Access Compliance Report

Public Rights-of-Way

(Pedestrian Signals)

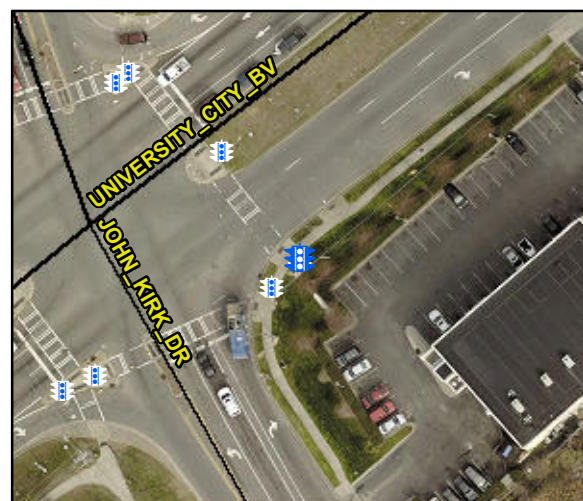
Intersection ID: N/A	Main Street:	Cross Street: N/A	Location: N/A
ADA ID: 1EADC27DE671	Signal Type: One Push Button-Non APS	Overall Compliance: No	Severity Score: BTN 1: N/A BTN 2: N/A No BTN: N/A
Codes/Mitigation Info/Possible Solution		Field Measurements/Component Compliance

PROW/ADA: TMUTCD 4e.08, R404.7.2

Possible Solutions: Replace Signal Push Button With APS Button on New Post. Remove & Relocate Sign.
